Change Order Request

#0348- Rineyville Elementary School
275 Rineyville School Rd
Rineyville, KY 40162

Change Order Request: 043

RE: Rineyville Elem. School
Architect Project No. 0508
Gym Modifications

NEW ELECTRICAL ROOM IN GYM

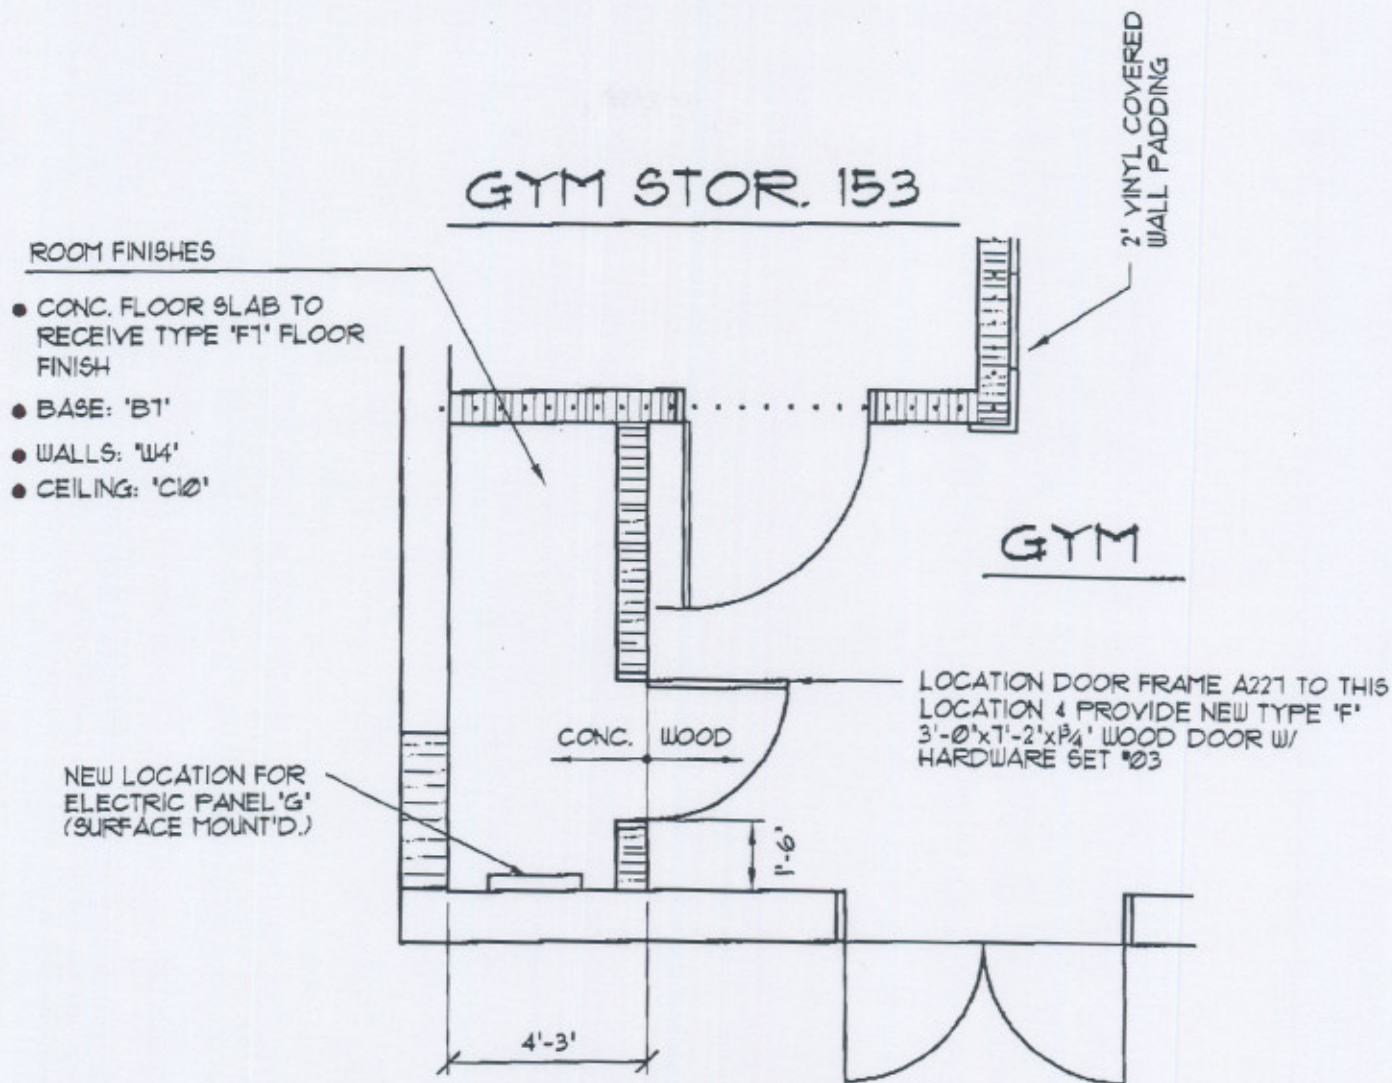
Attached is a copy of PFGW's Mod. #31 dated October 5, 2007 regarding the installation of a new electrical closet in the Gym near the Gym. Storage #153. The following list of modification are to also be included with this change.

- Delete acoustical tile ceiling system in A/V #151 and provide mount support for the "F4G" light fixture at 9'-0" above finish floor.
- Location door frame A227 to location shown on the attached Mod. No.31 and provide new Type "F" 3'-0"x7'-2"x 1 3/4" wood door. Provide Hardware Set #3 for this door to match A/V #151 door A151.
- Provide Room Finishes as shown on the attached Mod. No. 31 drawing.
- Relocate gym electrical panel "G" and surface mount panel as shown on the attached Mod. No. 31 drawing.
- At door location A227 - Provide a 10 3/4" deep hollow metal frame and prep to fit wood door and hardware presently under existing contract

- Provide a side wall sprinkler head at 9'-0" above finish floor similar to the one shown on sheet SP-1 in the A/V #151 of the contract documents.
